Report to the Independent Planning Commission (IPC) following the 23 January, 2024 site inspection

General question for consideration:

Salt from groundwater emerging from the Western Coal Services site in 2016. This location is on the Castlereagh Highway, 250m north of where LDP001 crosses the highway [image by K Muir taken 9 April 2016, that is, before the Water Treatment Plant.]

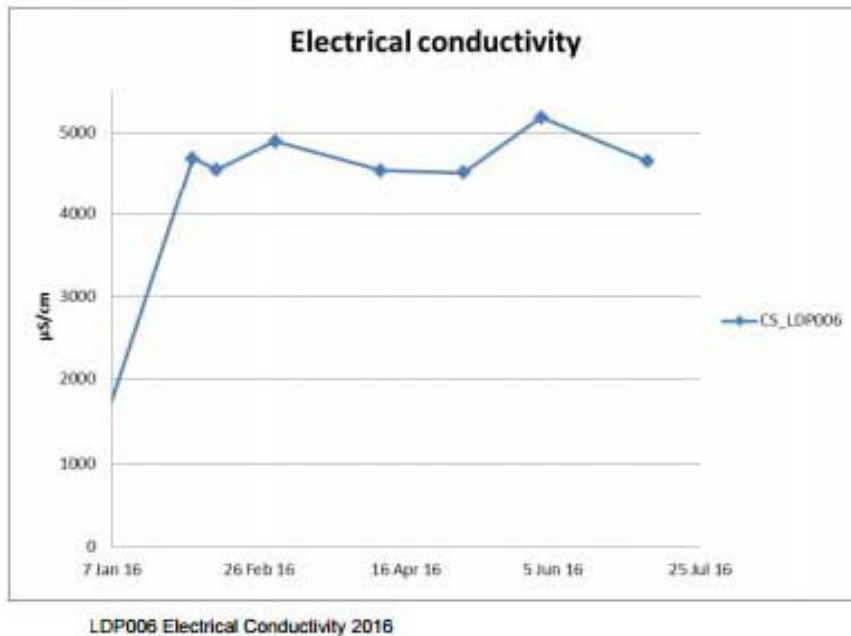
Does the Springvale Water Treatment Plant make a material difference to the water quality of the Coxs River catchment when the salt from that plant is placed on an unlined Ash Emplacement Area located above where the following image was taken in 2016?

Recall how salt was observed on Tuesday emerging from the near the base of the reject emplacement area (REA) at the Western Coal Services (WCS) site on Tuesday's site inspection. Even the dewatered sediment sludge deposited in the REA does not prevent salt migration from this large, unlined REA that is open to the elements.

Underground and open cut coal mining covers the Western Coal Services (WCS) site and the fly ash-salt emplacement area. The light cross-hatching indicates the location of the bord and pillar mine workings.

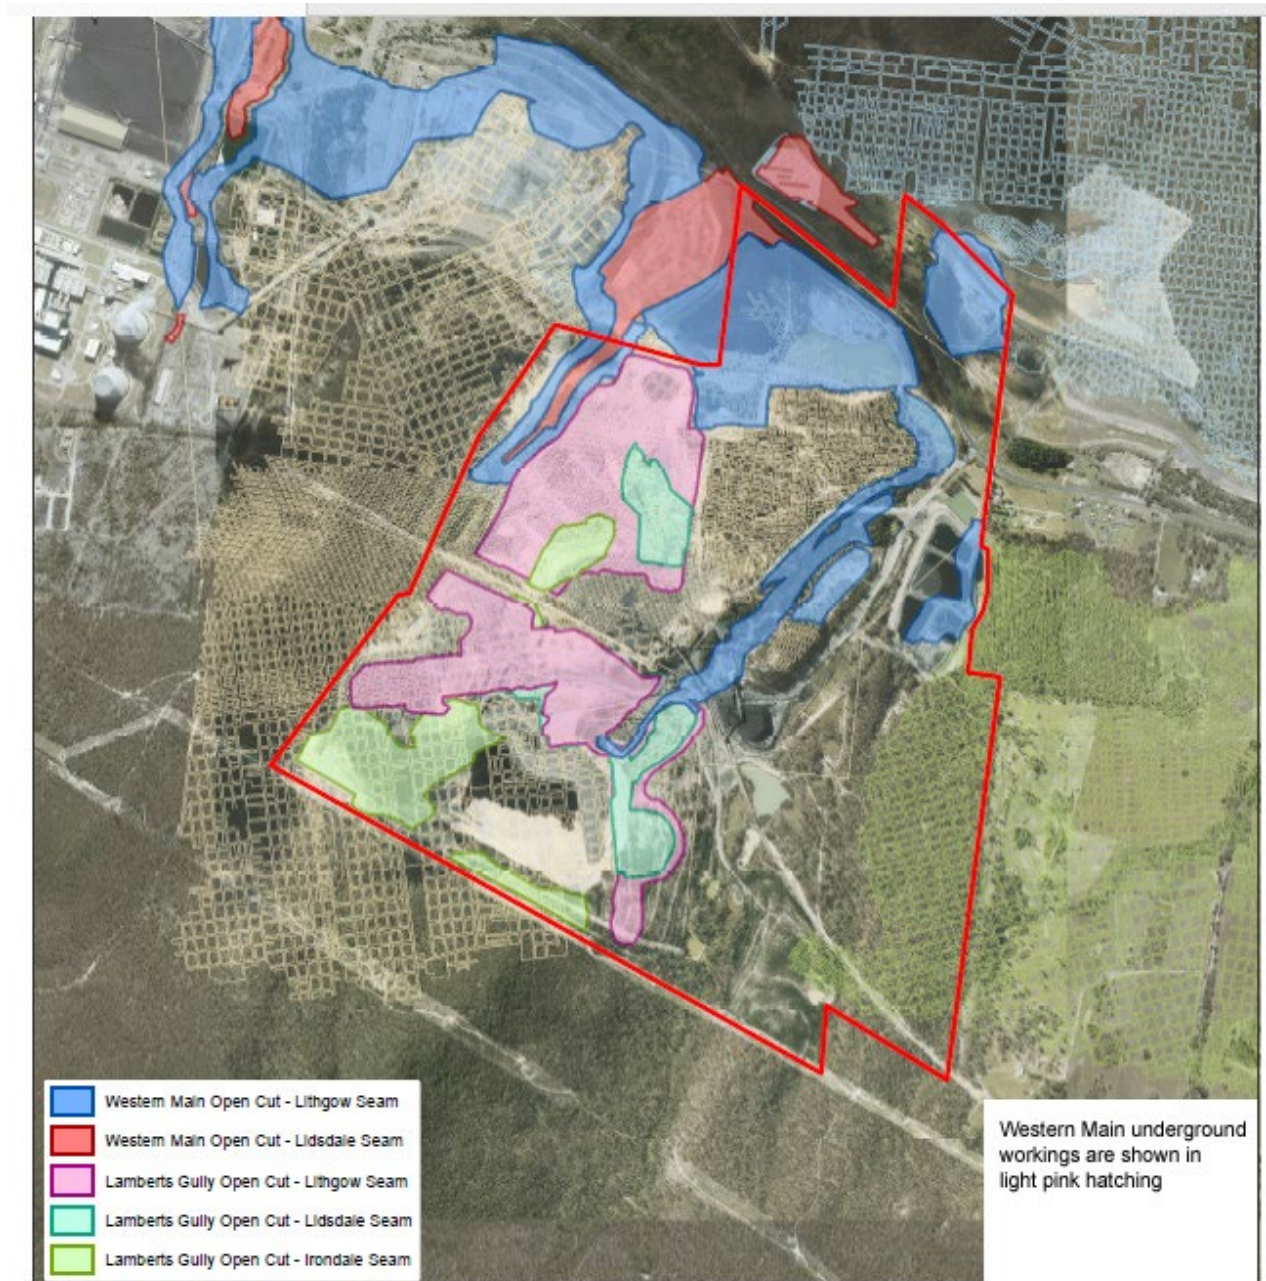
Taking the salt from the 42ML/day of mine waste and placing it on an unlined emplacement area is not going to lead to a neutral or beneficial effect on the Coxs River, particularly as the emplacement area lies above former coal mine workings (see figure, following page).

The waste emplacements on WCS site are unlined as are the fly ash-salt emplacement areas.

It is essential that saline groundwater draining from the WSC site and the fly ash-salt emplacement area are better controlled. Energy Australia's initial salt Interception project for the ash emplacement involved installation of boreholes to intercept that saline groundwater that had migrated off-site and to then pump it back to the ash repository. This approach was apparently unsuccessful. The current approach is to intercept the brine in groundwater below and around the ash repository and pump it to adjoining lined ponds (See [Mt Piper Brine in Ash Co-Placement | EnergyAustralia](#)).

The matter of salt emplacement in a sealed containment area should be imposed as conditions of consent for SSD-7592 (mods 9 and 10). Alternatively, as the Water Treatment Plant crystallises the brine, it can be easily transported, why not remove that salt out of the water supply catchment? (Note: the Kurnell Desalination Plant disposes of its brine through the off shore diffusers of the Sydney Sewage Treatment Plant system where it ultimately flows into the ocean).

Figure above indicates the relationship between the reject emplacement area, mined coal seams and Wangcol Creek [from WCS Mod 1 Statement of Environmental Effects, volume 2 Appendix D, figure 4.2 Nov 2015 regarding the groundwater model].

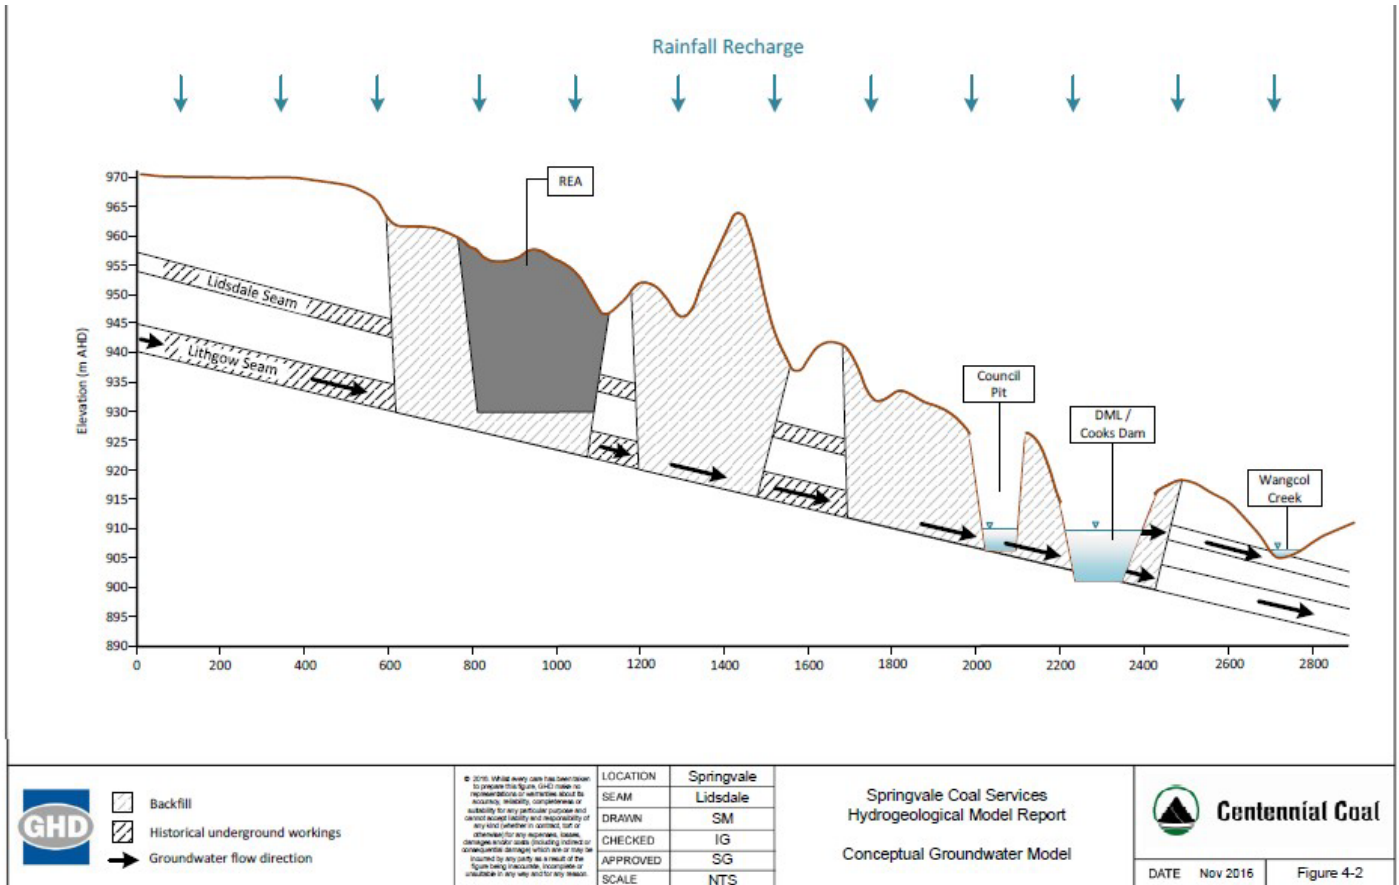
Non-point salinity pollution of Wangcol Creek by the emplacement areas at the WCS site and the fly ash and salt emplacement areas associated with the Springvale Water Treatment Plant is certain to increase over time towards the 2016 salinity levels recorded at LDP001 (LDP006).

Bord and pillar mine workings extend through in the coal seams indicated in the above GHD figure. These mine workings operate like an underground lake and mix the leachate from the Reject Emplacement Area [and the salt and fly ash emplacement area – not shown] to produce a large saline underground storage feeding Wangcol Creek, bottom right of GHD’s figure.

Figure 5-27 Groundwater level cross sections

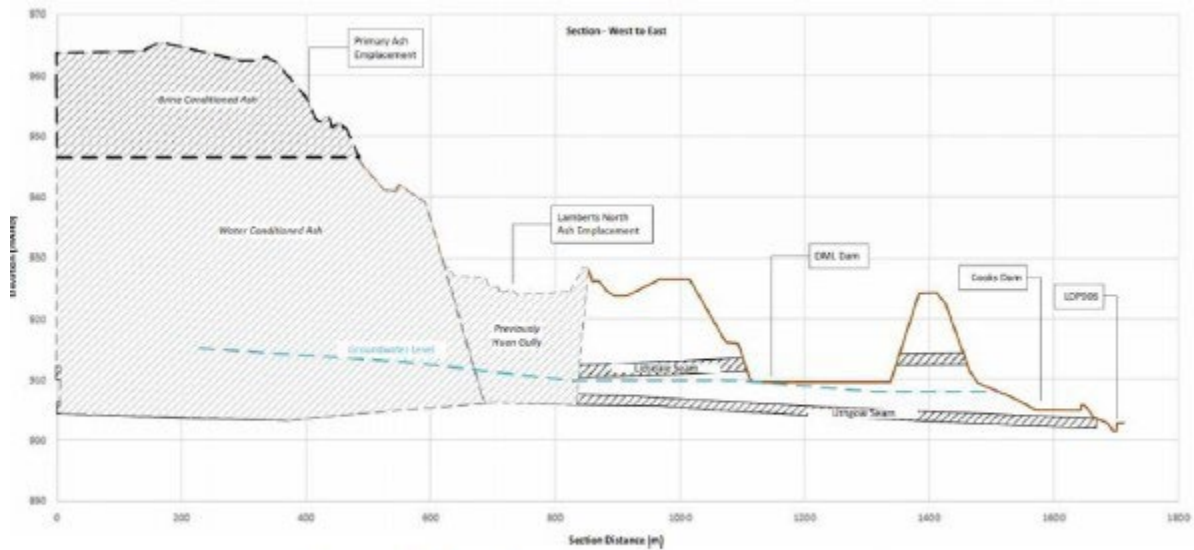
This figure indicates the relationship between the ash [and salt] emplacement area (left), ground water level in blue and LDP6 (now LDP001) (on right). It is a very poor arrangement.
